Our Ref: 17068  
Council Ref: SSDA 8517 & SSDA 8449

**RE: SSDA 8517 and SSDA 8449 - Response to Request for Further Information**

This letter has been prepared on behalf of Mirvac Projects Pty Ltd (Mircac) to respond to the issues raised by the Department of Planning and Environment (Department) and other key stakeholders following their assessment of the Response to Submissions (RTS) reports submitted to the Department in support of SSDAs 8517 and 8449. A Response to each of the issues raised is set out below.

**Figure 1 Loading Dock manoeuvring constraints**

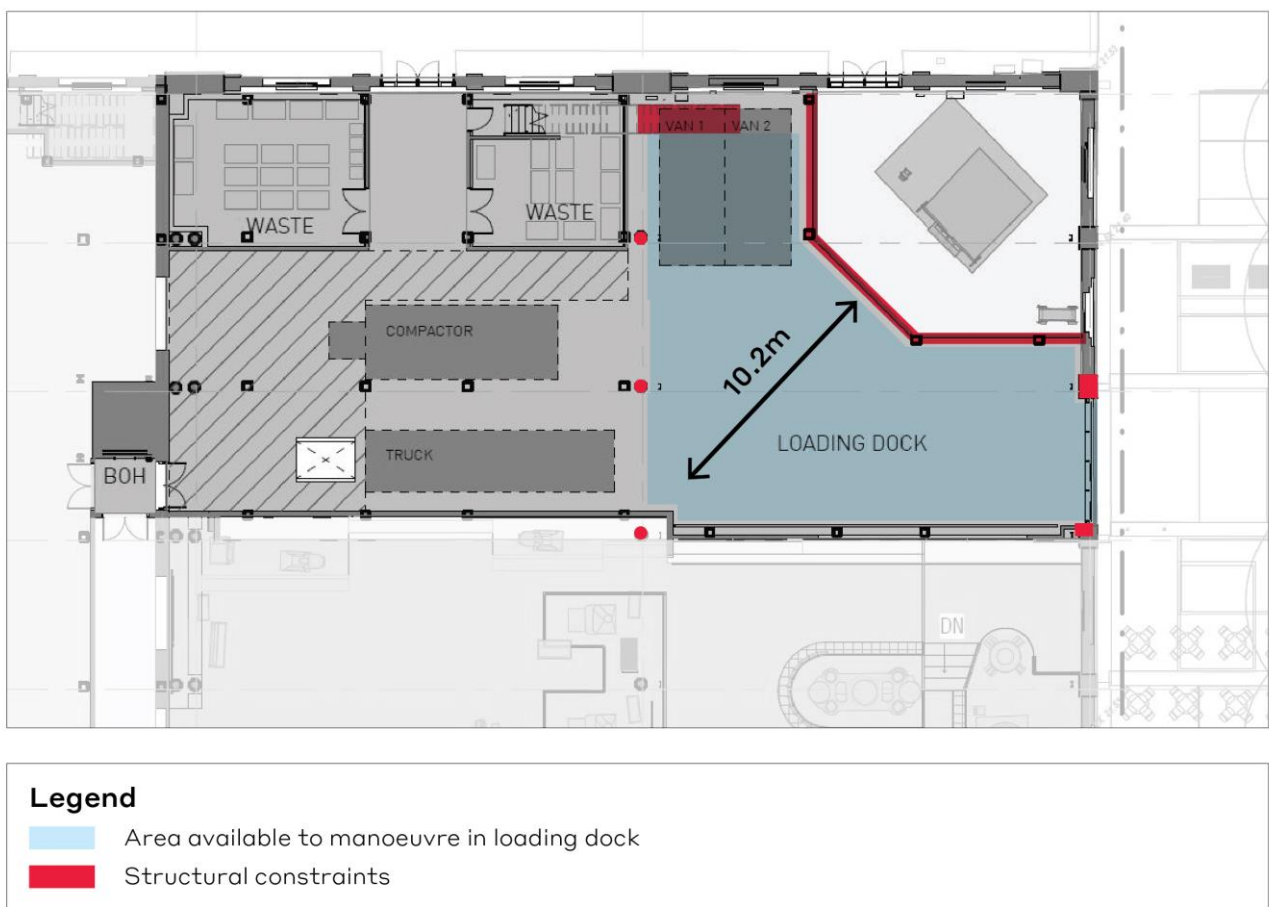
*Demonstrate how trucks can enter the loading dock from Innovation Plaza in a forward direction and exit in a forward direction (with all reversing movements occurring within the loading dock).*

The proposed design of the loading dock does not allow the proposed 10.2m long trucks to enter and exit the loading dock in a forward direction from Innovation Plaza. The swept path plans submitted with the RTS Report for SSDA 8517 illustrated that service and waste vehicles can exit the loading dock in the forward direction but must reverse to enter from Innovation Plaza.

The analysis has found that the area for manoeuvring vehicles within the loading dock is significantly constrained by the proposed access stairs located adjacent to the northern wall above the van parking spaces; the glass barrier that surrounds and protects the Davy Furnace; the size of the loading dock door and the existing heritage columns, as identified within **Figure 1**. Accordingly swept path assessments have indicated that in order for trucks to complete the three-point turn necessary when entering in a forward gear, the following would occur:

- the 10.15m Large Rigid Truck would conflict with the access stairs above the van spaces, conflict with the Davy Furnace barriers and reverse in very close proximity to the heritage columns. Due to the location of the heritage columns and the loading dock doorway, extending the loading dock wall further south towards the Davy Furnace would not improve the manoeuvrability of the trucks;
- the 10.2m Refuse Collection Truck would need to undertake a 5-point turn and rely on the van parking spaces being unoccupied. Furthermore, there would be a high chance of the trucks colliding with the Davy Furnace barriers, the access stairs above the van spaces and heritage columns. Repositioning of the loading dock wall would also not improve the manoeuvrability of the trucks.

In addition, the installation of a mechanical turn-table within the loading dock has also been assessed and considered to not be an acceptable option for the following reasons:

- the size of the turning circle that would be required would only leave approximately 20-30cm of tolerance space between the rotating trucks and the Davy Furnace barriers, the heritage columns and the southern portion of the loading dock wall. It is projected that there would be a high probability of rotating trucks colliding with the built form of the building;

- the mechanical infrastructure and depth of the pit below a turn-table would be significant and likely give rise to significant and irreversible heritage impacts;
- the visual appearance of a turn-table would give rise to significant visual impacts upon the aesthetics of the space, particularly considering that the portion of the loading dock within Bay 1 has been designed to not look like a loading dock when trucks are not utilising it; and
- the installation of a turn table has a high risk of mechanical failure which would give rise to operational issues such as queueing of trucks and additional conflict with pedestrians.

On the basis that all loading and servicing activities will be undertaken in strict accordance with the provisions that will be set out within the Loading Dock Management Plan, the proposition of trucks reversing a short distance into the loading dock and exiting in a forward direction is considered acceptable.

**Figure 2 Existing service access route**

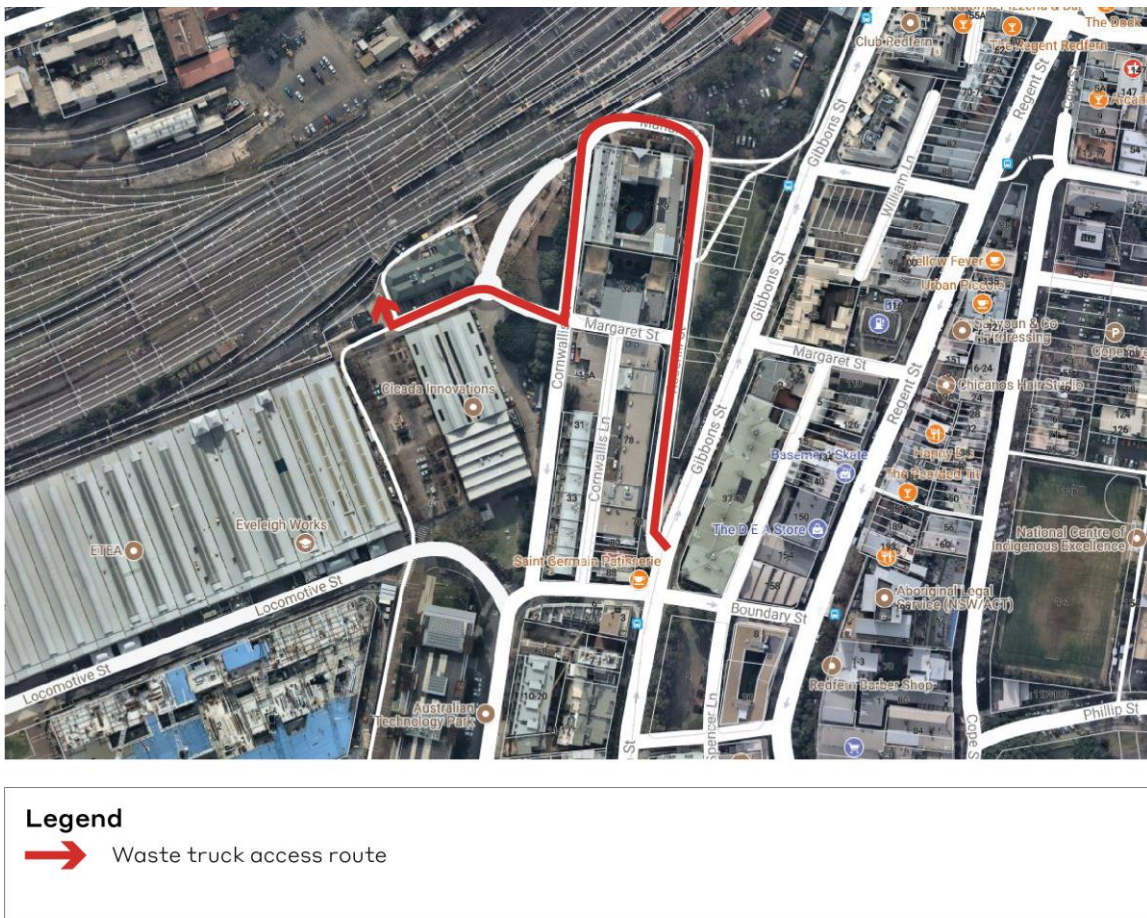
*Advise how waste trucks (i.e. route and length of truck) currently access the refuse area located north of Innovation Plaza.*

At present, Refuse Collection Trucks that service the Locomotive Workshop have an overall length of 8.0m and service the site 3 times per week. The trucks enter the ATP site from the northern access off Cornwallis Street at the junction with Margaret Street and then drive between the IBA Building and the NIC Building, before turning into Innovation Plaza and reversing to the waste storage compound located to the north of Innovation Plaza and adjacent to the rail line (refer to **Figure 2**). Staff within the Locomotive Workshop transfer their own waste to the waste storage compound.

The existing waste storage compound is not suitable to accommodate the significant additional quantity of waste that will be generated by both the commercial tenants and the retail operators by the Locomotive Workshop redevelopment. It has been demonstrated within the EIS and the Waste Management Plan Report that the proposed volume and different waste streams can be effectively managed, sorted and stored within the loading dock.

Figure 3 Proposed extension of the Rosehill Street parking restriction area

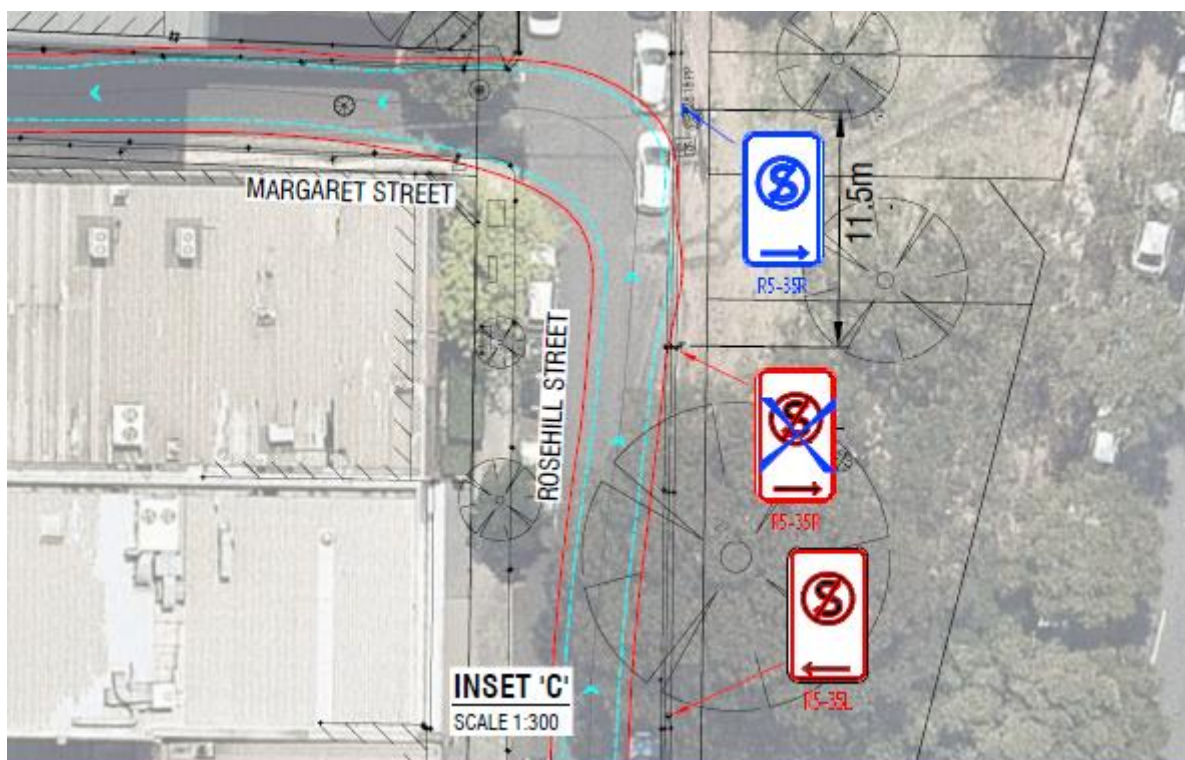
*It is the City's preference that the service vehicle travel route should exclude the Shared Zone on Marian Street. If Option 1 via Rosehill Street and Margaret Street is pursued, as stated in previous correspondence, any changes to the existing road network will need to be referred to the Local Pedestrian and Traffic Calming Committee for endorsement and the applicant bears the risk that works may not be endorsed.*

Mirvac's preference is to utilise Option 1 – the Rosehill Street- Margaret Street-ATP site and will work with the Local Pedestrian and Traffic Calming Committee to seek endorsement for the 11.5m-12m extension of the current Rosehill Street 'No Stopping' parking restriction near Margaret Street.

To clarify, this extension would only require the relocation of a single signpost and would result in the loss of two on-street car spaces as illustrated in **Figure 3**. No other changes to Rosehill Street or Cornwall Street would be required.

Notwithstanding this, as outlined in the RTS report, travel by the nominated 10.2m rigid truck via Option 2 – the Rosehill Street-Marian Street-Cornwallis Street -ATP site route is physically possible, legal and is not envisaged to result in any safety or operational issues. Mirvac therefore do not accept the Council's proposition of excluding the use of Option 2, if, for unforeseen circumstances, Option 1 cannot be used.

Figure 4 Coach parking bay location plan

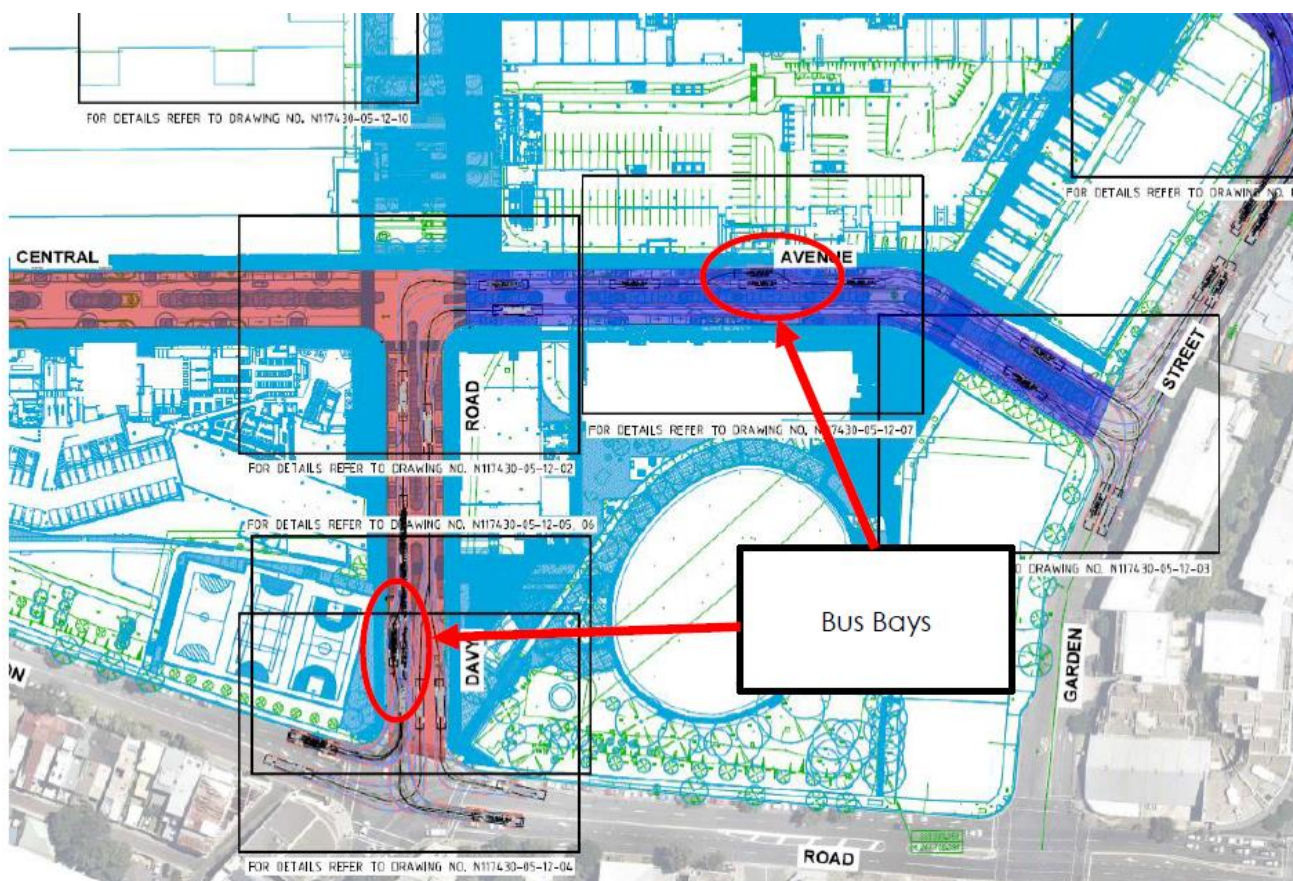
It is noted that the event and function component of the existing development will be replaced by commercial uses that are proposed as part of SSD 8157 for bays 5-16. However, as stated in the response to submissions, as part of the activation of the Locomotive Workshop, some events are still proposed to be held within Bays 1-4a and Innovation Plaza on a regular basis. As a result, provision for coaches should be incorporated into the proposed development.

TfNSW requests that the applicant be conditioned to prepare a Coach Parking Management Plan in consultation with the Sydney Coordination Office within TfNSW, prior to the issue of the Construction Certificate.

Details on how vehicles, including coaches, accessing functions can be accommodated within Locomotive Street should be provided. If provision for coaches cannot be accommodated along Locomotive Street, an alternative location along other internal streets within the ATP should be identified, in consultation with the Sydney Coordination Office.

In conjunction with SSDA 7317, it is intended that one permanent coach parking space will be provided on Davy Road West and one temporary coach parking space will be provided on Central Avenue north as illustrated in **Figure 4**. The details of these proposed coach parking spaces have been confirmed within Mirvac's correspondence to TfNSW pursuant to Condition B52 to SSDA 7317.

Notwithstanding this, as set out in the RTS Report for SSDA 8517, the likely events that will take place within the Locomotive Workshop and Innovation Plaza, will be community- based temporary events or private corporate events whereby visitors will travel by public transport, taxi's or their own private means. Not coaches. Accordingly, it is not considered necessary for a Coach Parking Management Plan to be prepared for the Locomotive Workshop redevelopment.
